SITE APPLICATION DEFICIENCIES

Address or legal description 286XX 176th Ave. SE

Parcel # 362205-9171

Designer W. L. Casper

LATERAL LAYOUT

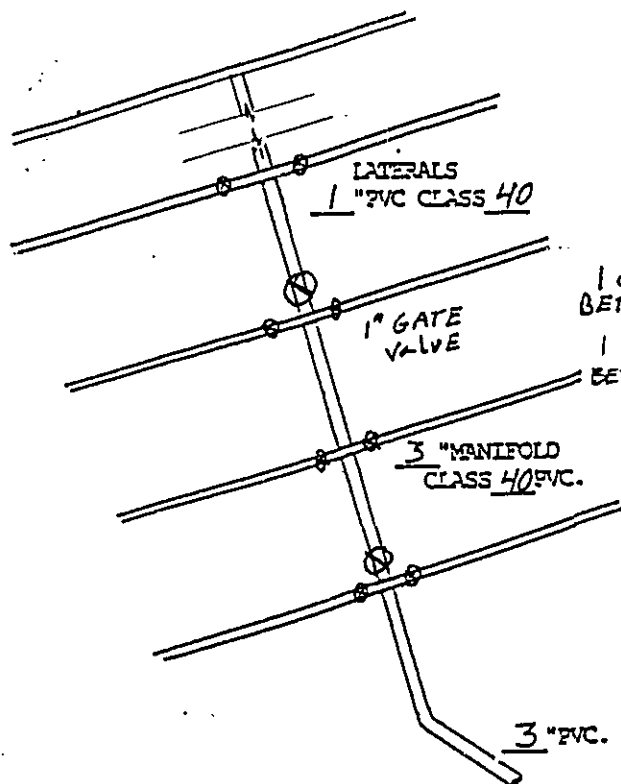
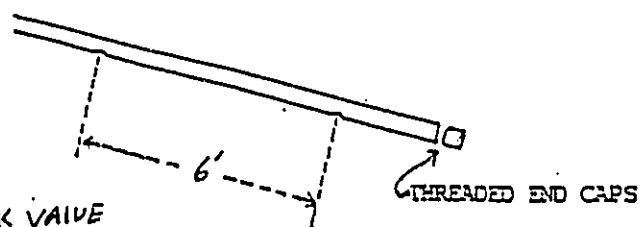
3) No construction or details - insufficient detail for design or construction.

4) No way to verify dosing calculations.

TOPOGRAPHIC SURVEY FOR:		
JEFF POSCHWATTA		
SCALE: 1" = 20'	APPROVED BY:	DRAWN BY GB
DATE: 11-09-91		REVISED
		DRAWING NUMBER 01 0217

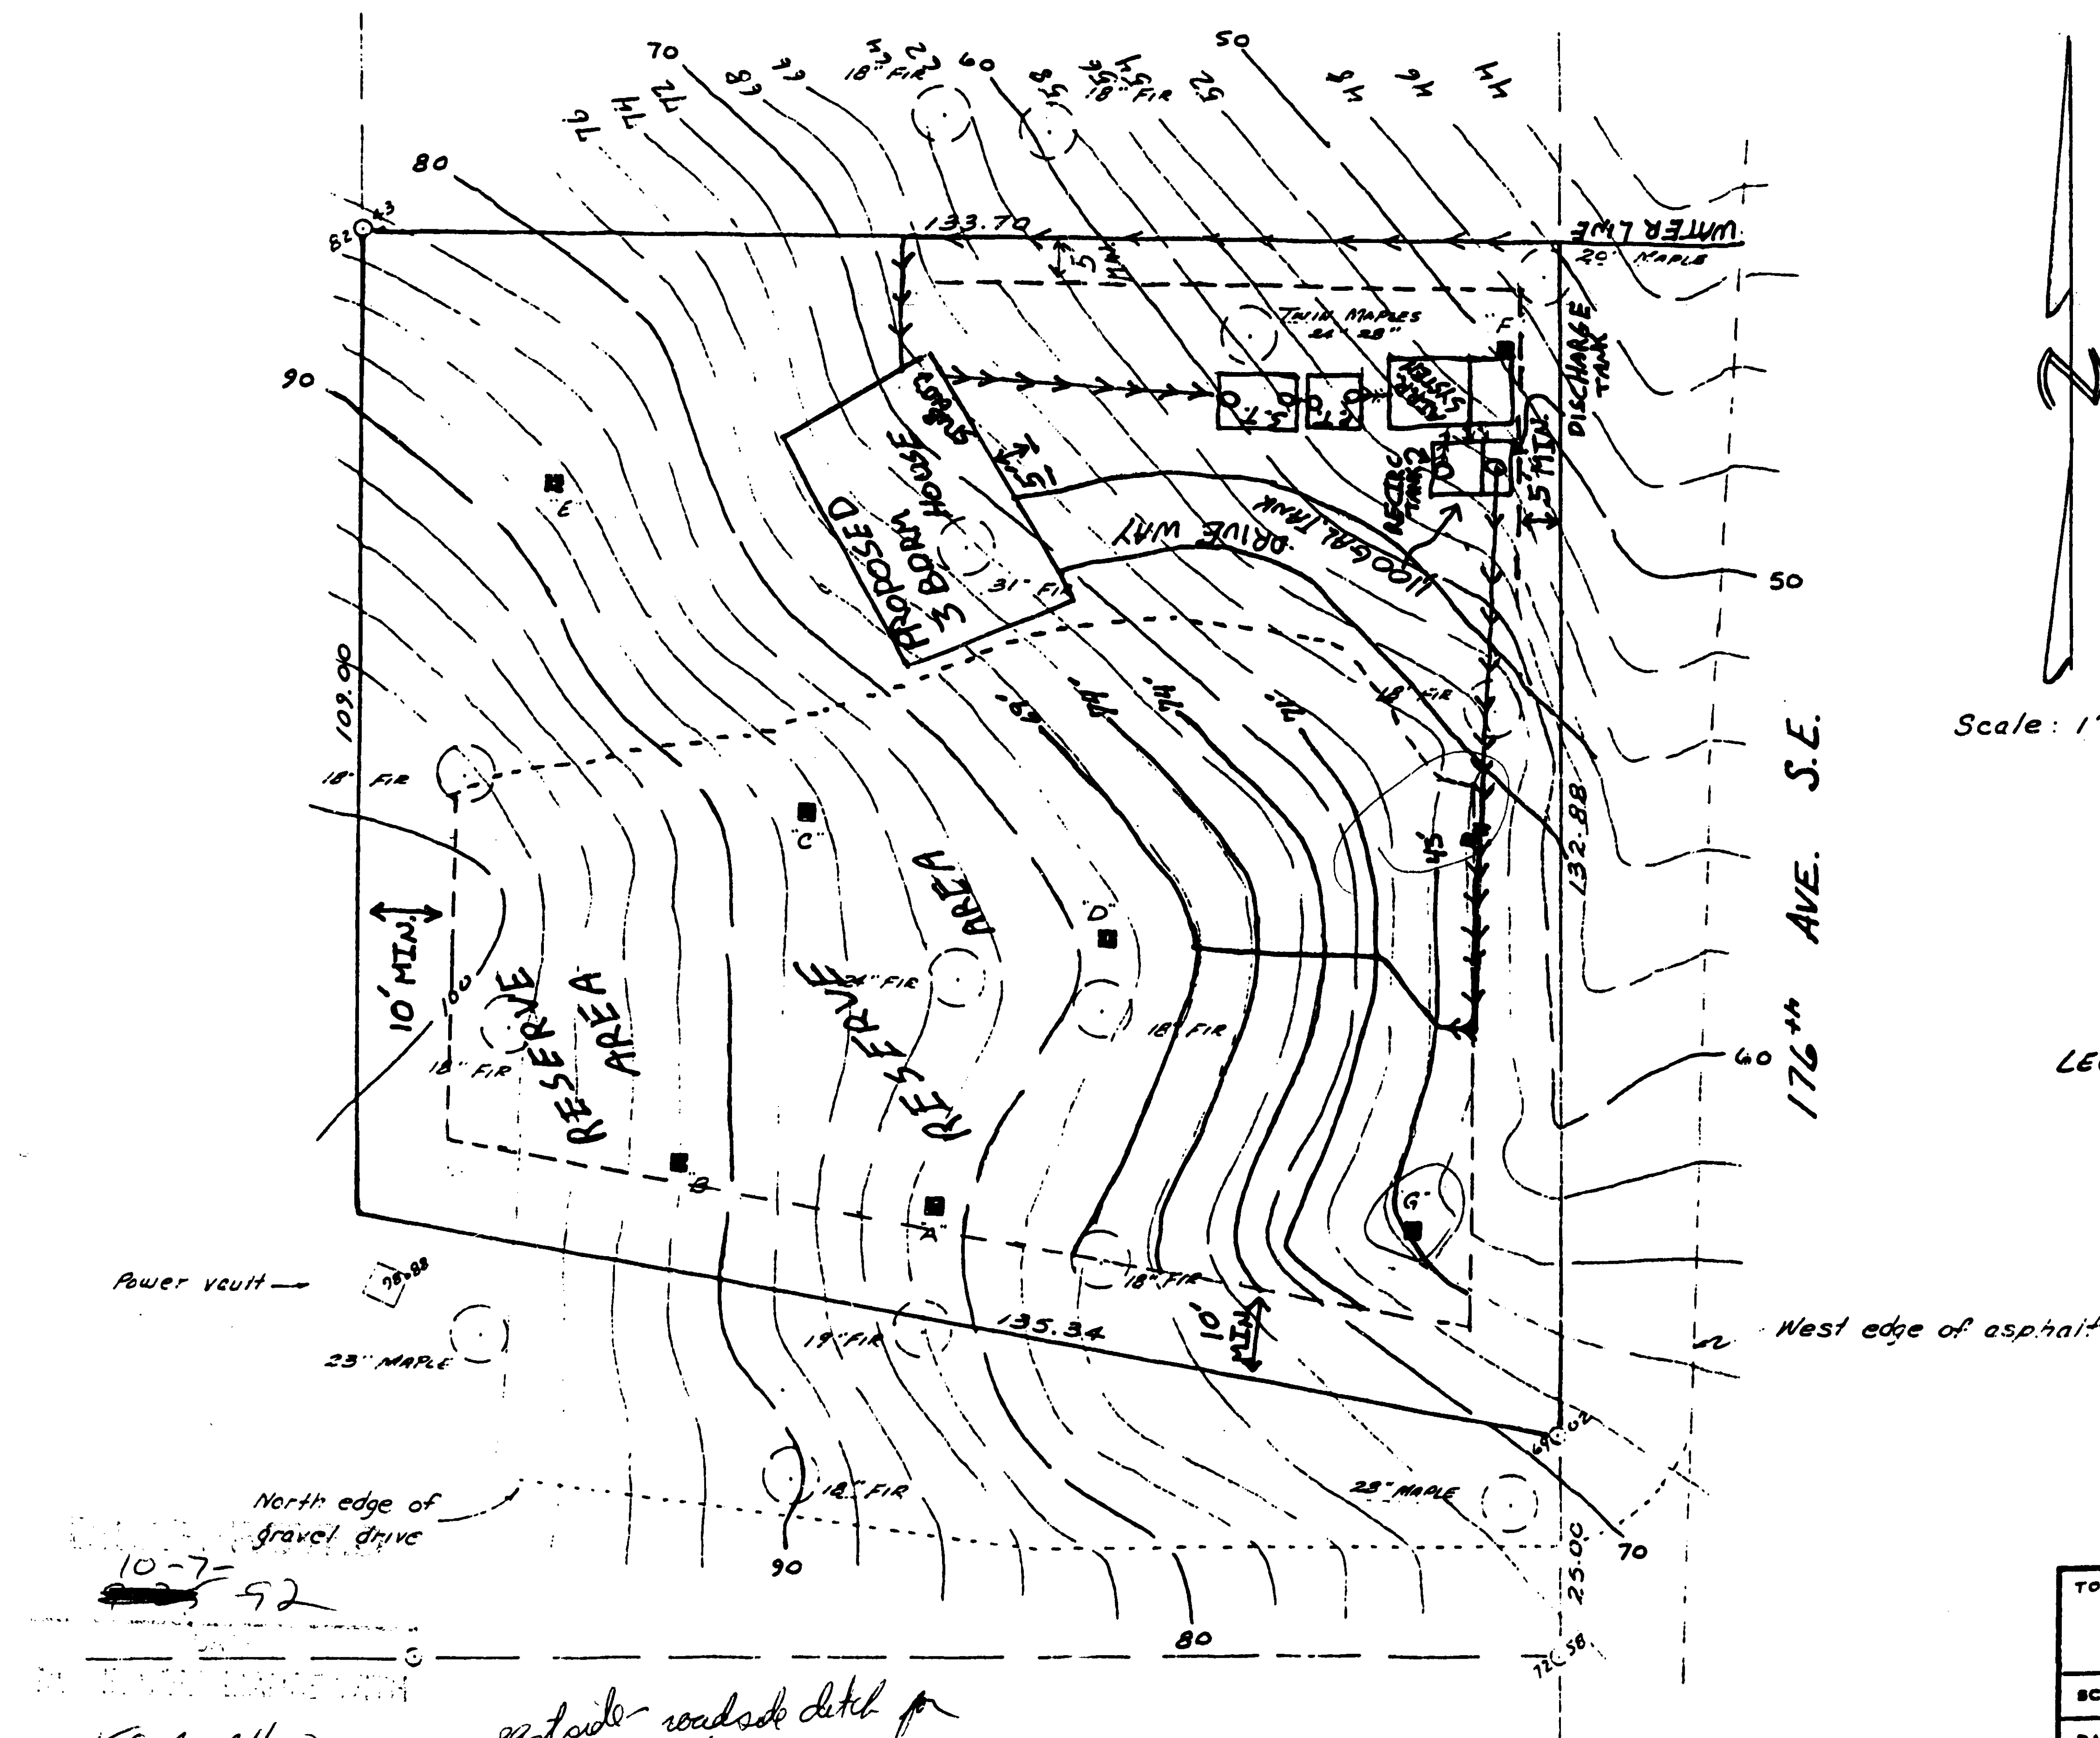
a) The topography of the lot is steep and uneven. Topographic
lines are inconsistent with the design. It would not
be possible to install this design as shown without
a large variation in installation depth.

2) The lowest soil evaluation pit is 8-10' higher on the
upslope side than the downslope side and is actually a cut.

The drainfield lines must be at least 50' from this cut.

6. It appears that the driveway location as specified on the plot plan would necessitate the creation of additional soil cuts for which additional drainfield setbacks would need to be maintained.

Drainfield slope is within permissible limits as shown on the topo. We have also increased the drainfield length to 50 feet more than code minimum. This reduces application rate from .8 to .68 gal/sq.ft. Considering that the effluent comes from a recirculating sand filter we trust the Health Officer will agree there is no threat to public health with this revised design.
